APPENDIX C

Public Scoping Documents

APPENDIX C1 - INDEX TO PUBLIC SCOPING COMMENTS

Table C-1. Scoping Commenters and Comment Set Numbers

Fig. 1. ACEC and Wildlife Linkage Design. Credit: B. Hammer.

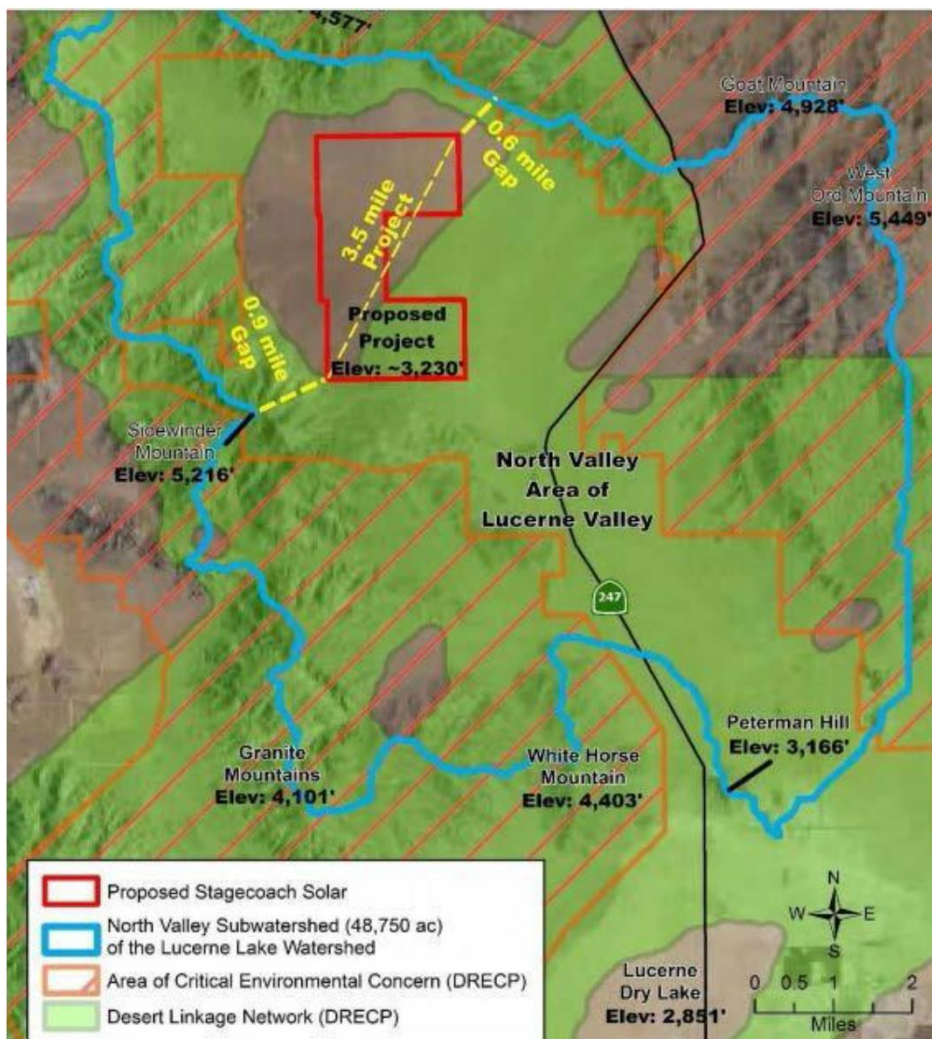
The proposed large-scale solar project is situated within a Desert Linkage Network [DRECP], Fig.1, and surrounded by Stoddard Ridge, Black Mountain, Sidewinder Mountain and Highway 247.

B5-1
cont.

Mojave Desert Land Trust	
B5-1	Section 4.3.1.5, <i>Biological Resources</i> describes the southern end of the gen-tie line route as crosses private land adjacent to the Granite Mountain Wildlife Linkage ACEC (see Figure 4.3-6 Wildlife Movement). The gen-tie route is not on BLM land so is not subject to BLM ACEC management plans.
B5-2	Section 4.10, <i>Hydrology and Water Quality</i> , discusses impacts to groundwater supply related to water use during construction. More information is included in the Water Supply Assessment, included in Appendix D.
B5-3	Section 5, <i>Alternatives Screening, Identification, and Impact Analysis</i> discusses the alternatives to the Project. The use of DFAs defined by the DRECP, or private lands around Kramer Junction, Trona, Hinkley, El Mirage, and Amboy, are discussed. Section 4.3.1, <i>Biological Resources, Environmental Setting</i> (and Appendix F, BRTR) lists all plant and animal

Fig. 2. California Desert Linkage Network. MEA Assessment Coolwater-Lugo Transmission Project. CPUC. April 2016.

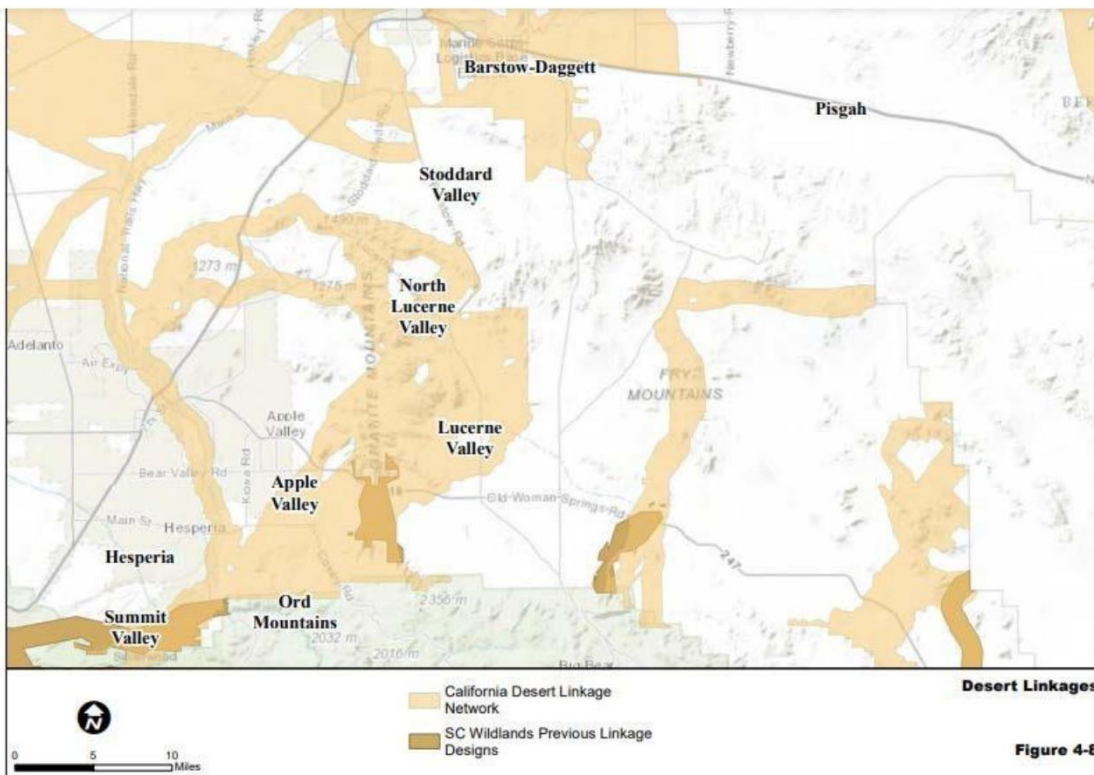
The Desert Linkage Map [Fig. 2] illustrates the extensive corridor network within the proposed Stagecoach site area. Lucerne Valley provides important connectivity from the San Bernardino Mountains north through the basins and ranges connecting with China Lake North Range and the southern Sierra. Several special status species are found within this region, including the desert tortoise, desert bighorn sheep, golden eagle, red-tailed hawk, Le Conte’s thrasher, and Bendire’s thrasher. In total, 11 special status plants and animals have been noted in the immediate vicinity of the proposed project. Moreover, as the NOP map confirms [Fig. 1], the proposed site area is surrounded by designated Areas of Critical Environmental Concern (ACECs), areas set aside as core habitat for potentially affected species.

Figure 3 - Distribution Model. Desert Bighorn Sheep. MEA Assessment Coolwater-Lugo Transmission Project. CPUC. April 2016.

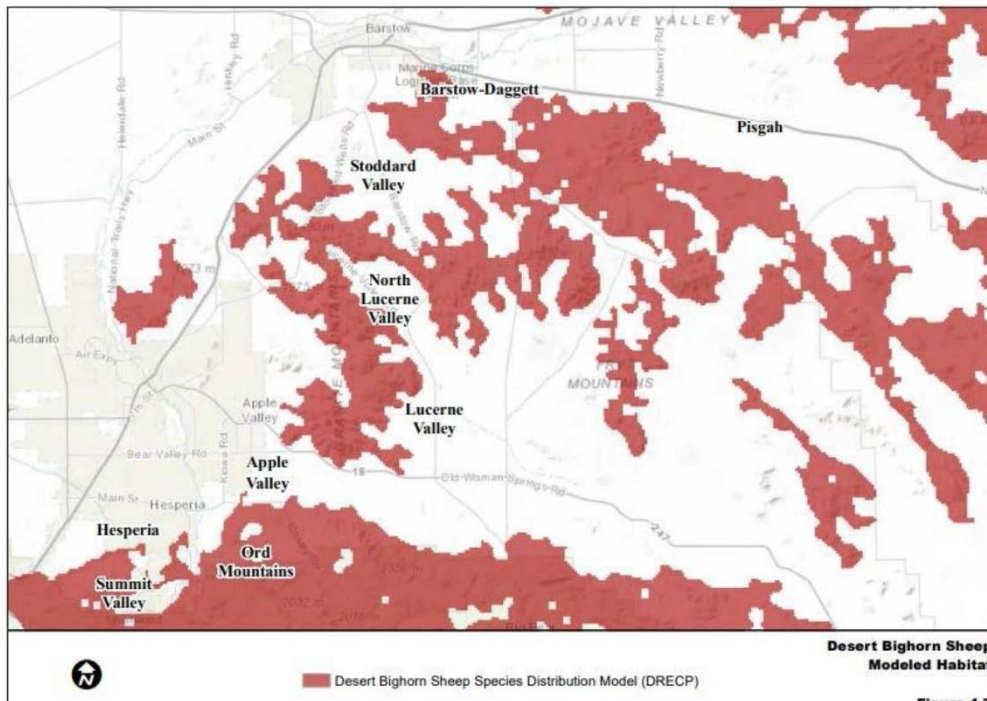
The proposed Gen-Tie route would run between the Granite Mountains and the Ord Mountains. This route is of concern in that per the DRECP, the Granite Mountain Wildlife Linkage, described as

sandwiched between Lucerne Valley and Apple Valley and including Granite Mountain, warrants new ROW proposals not interfere with or inhibit wildlife crossing and movement through the area. Moreover, the BLM advised that renewable energy is not an allowable use within the Granite Mountain corridor as renewable energy is not compatible with National Landscape Conservation System and ACEC unit values and criteria.³

Fig. 4. Overdraft groundwater map, DRECP. DataBasin DRECP Gateway. Indicated in yellow.

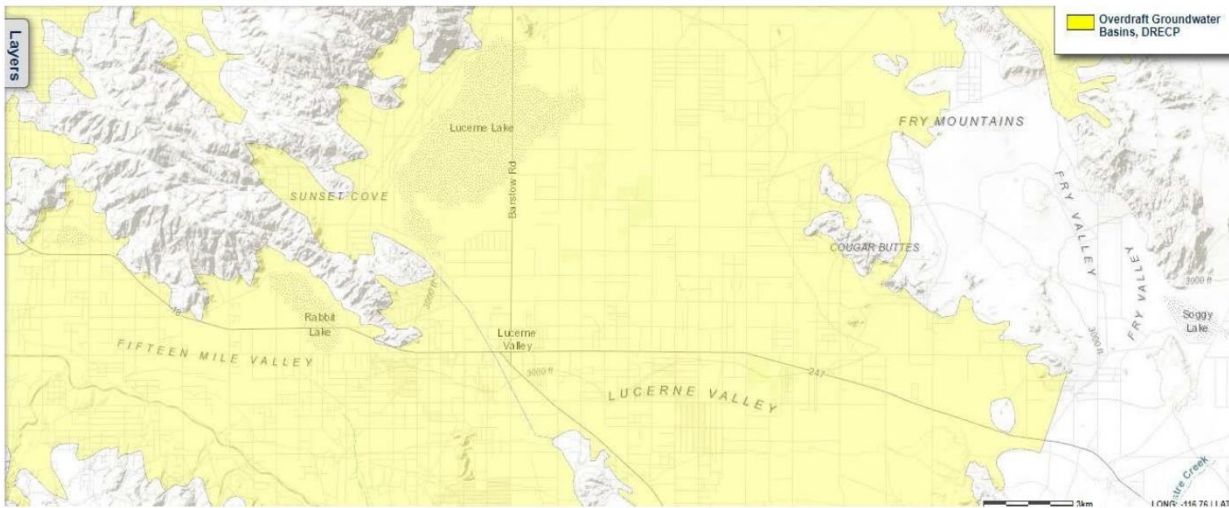
A second significant concern we have is the potential overdraft of groundwater. The project proposal area is located on the Este Sub-basin and directly in the middle of the groundwater sub-basin referred to as the “North Valley Subwatershed” of the Lucerne Lake Watershed Area. This already overused basin would be tapped into to provide enormous amounts of water for construction and operations of the project. The proposed application indicates that construction alone will use approximately 1,200-acre feet to suppress dust and move earth. On-site operations are estimated at 46-acre feet per year, with no amount disclosed for ongoing dust suppression.

**B5-2
cont.**
